CLARIFICATIONS TO PROPOSAL

The following section is added as a part of Proposal

ADDENDUM TO PROPOSAL

DATED 26 JUNE 1963

FIGURE 5B

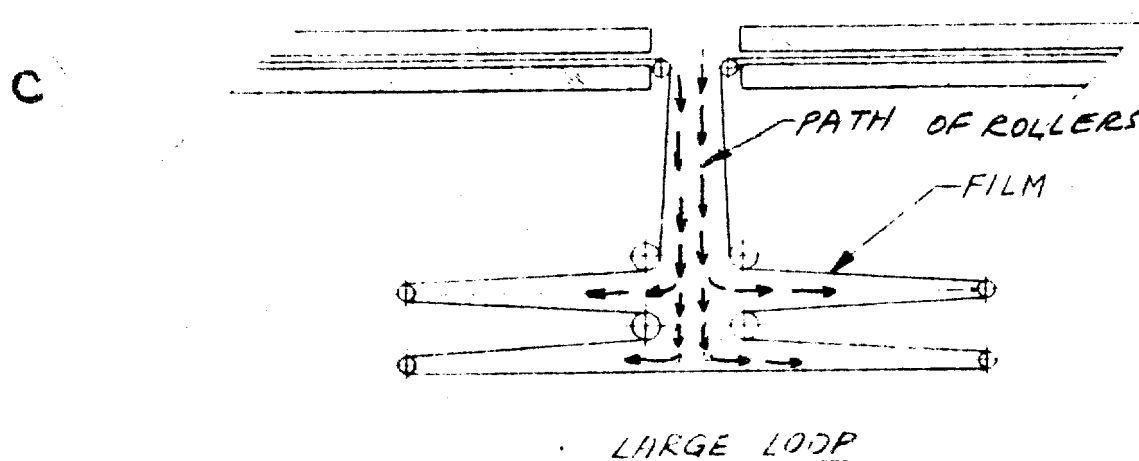
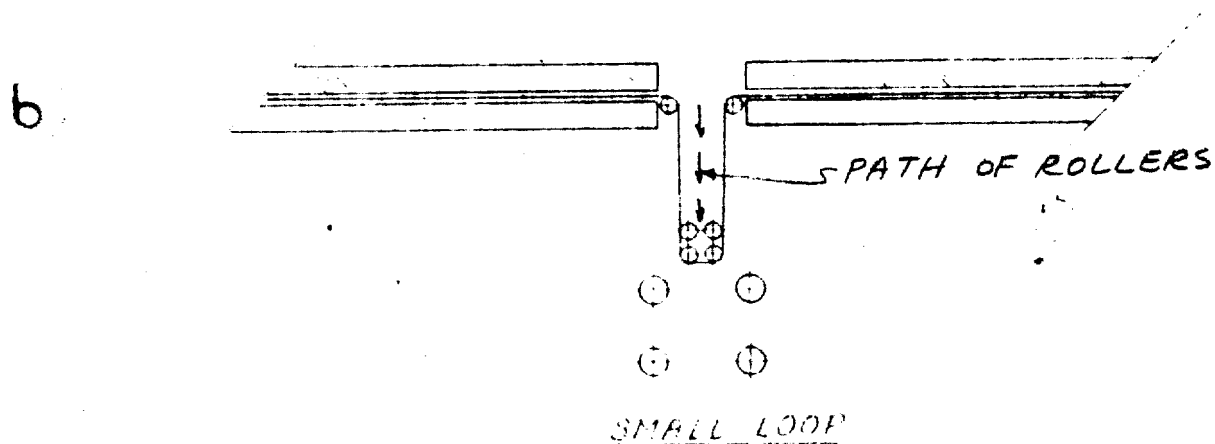
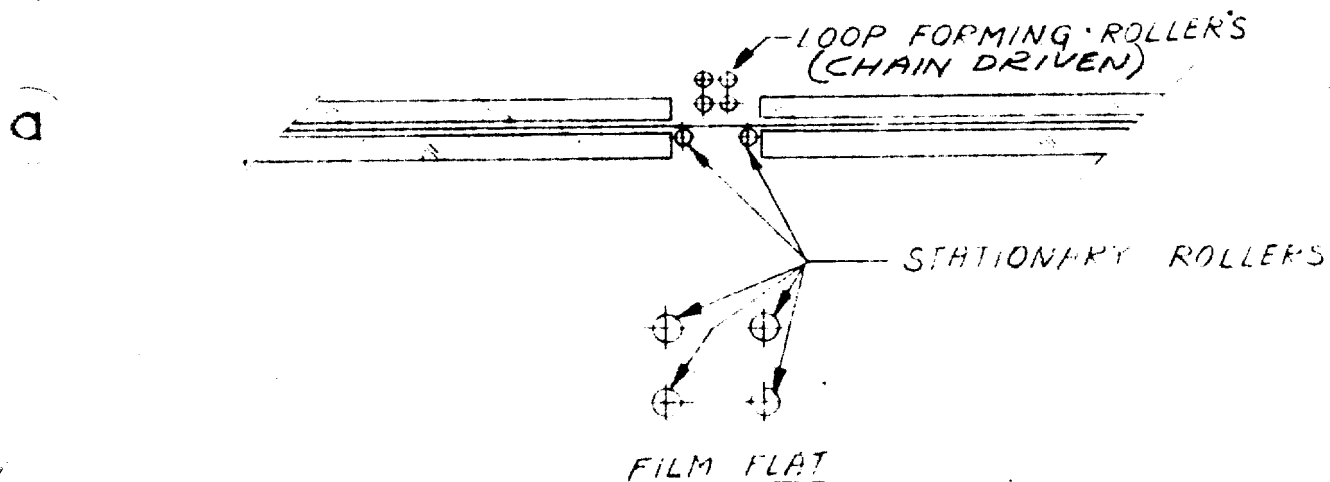
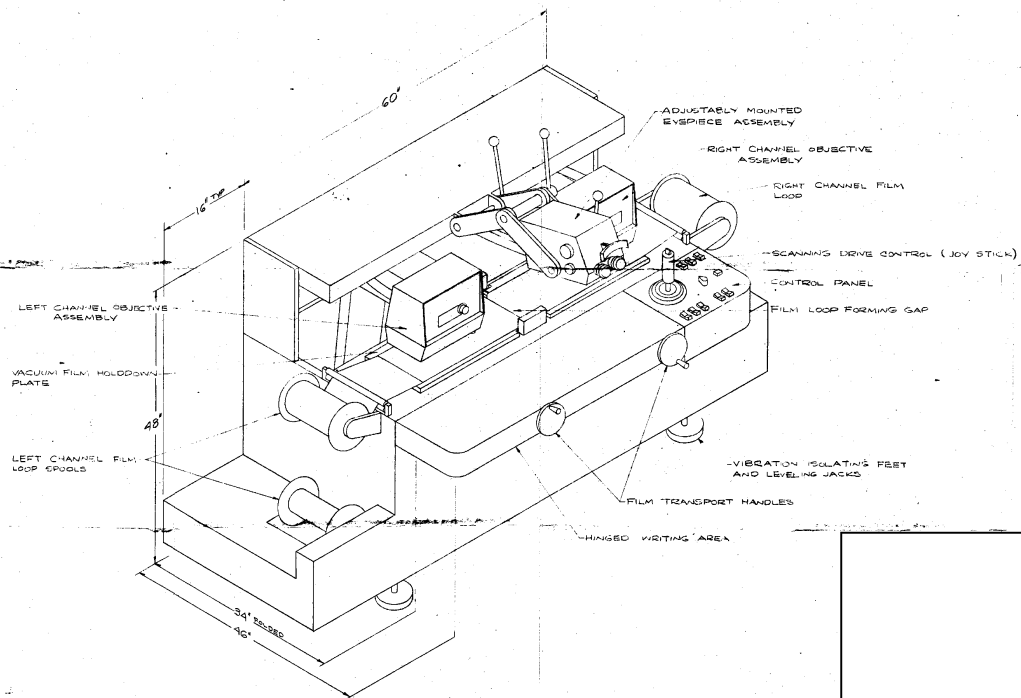
Alternate B

This approach to achieve an increase of the film loop to 24' minimum by incorporating a double set of rollers within the cabinet as shown in Figure 5 (B) attached. This arrangement necessitates increasing the number of rollers which are supported by the chain, in addition to modifying the support of the chains at film format level, and associated redesign necessitated by confined space requirement. The size and configuration of the viewer is not changed by this modification.
